UNITED STATES PATENT AND TRADEMARK OFFICE

APPLICATION NO.	FILING DATE	FIRST NAMED INVENTOR	ATTORNEY DOCKET NO.	CONFIRMATION NO.
09/602,690	06/23/2000	Donald Brian Eidson	01827.0037.00US00	1643

Office Action Summary

Figure 4, Page 300

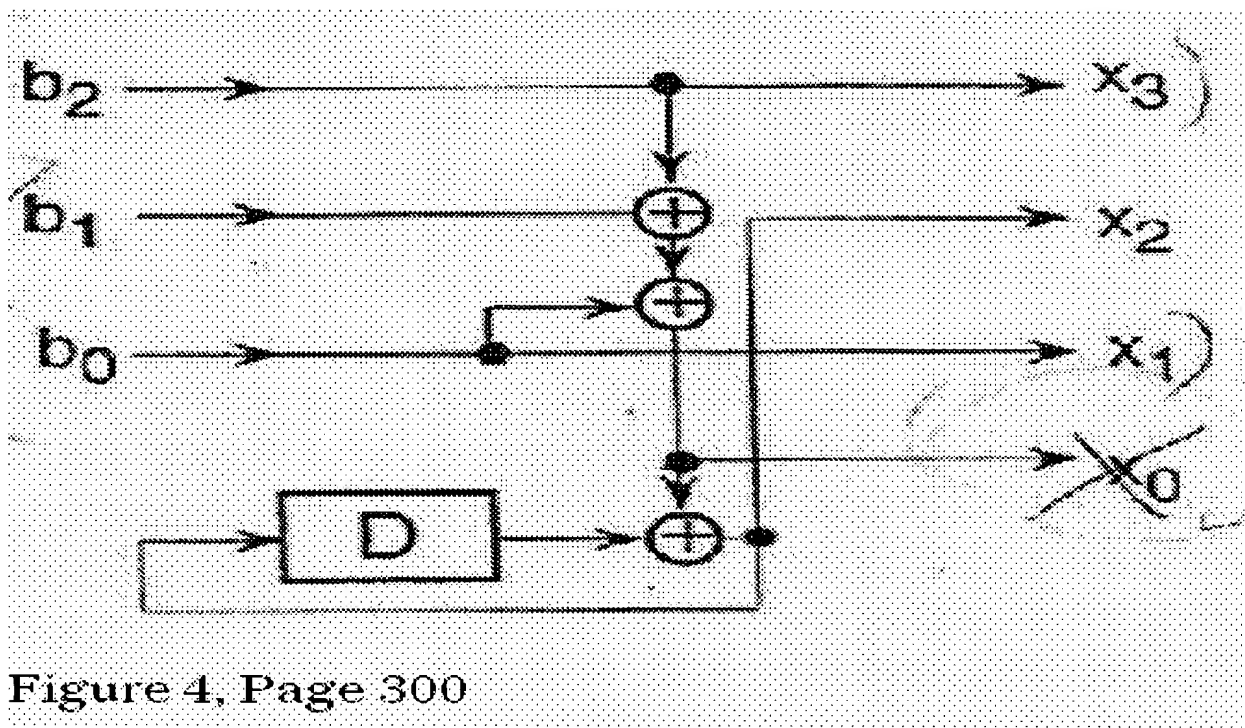
The Examiner would like to point out that in the above Figure 4, Benedetto teaches the limitations of claim 1 with slight modification. The following description is in reference to Figure 4 above: The adder connected to the output of the delay element has $(n+1)$ inputs, which are b_2 , b_1 , b_0 and the output of the adder. The output of the adder is formed in a feedback loop that includes a storage element. Furthermore, two of the three inputs of the encoder are unaltered, namely b_2 and b_0 , whose respective outputs are x_3 and x_1 .

Benedetto does not explicitly teach a rate n/n encoder as stated in the present application. The Examiner would like to point out that it is well known in the art that a rate of an encoder is defined as the ratio of the number of inputs to outputs. The limitation of claim 1 of the present application states a rate n/n , which essentially means that the number of inputs is equal to the

number of outputs. Referring to Benedetto's Figure 4 above, one of ordinary skill in the art at the time the invention was made would have recognized that by eliminating output x_0 would indeed have made the above-shown encoder a rate n/n . This modification would have been obvious to one of ordinary skill in the art because one of ordinary skill in the art would have recognized that by eliminating the x_0 output of the encoder taught by Benedetto in Figure 4 would have increased the coding gain at relatively low bit error rates. Furthermore, the Examiner would like to add that by removing the x_0 output also would have been an obvious design choice and not patentably distinct.

As per claims 2-3, Benedetto substantially teaches, in view of above rejections and Figure 4 above, a feedback loop that includes a single storage element wherein the input of the storage element is coupled to the output of the adder, and the output of the storage element is coupled to an input of the adder, and the n th encoder output is derived from the output of the storage element.
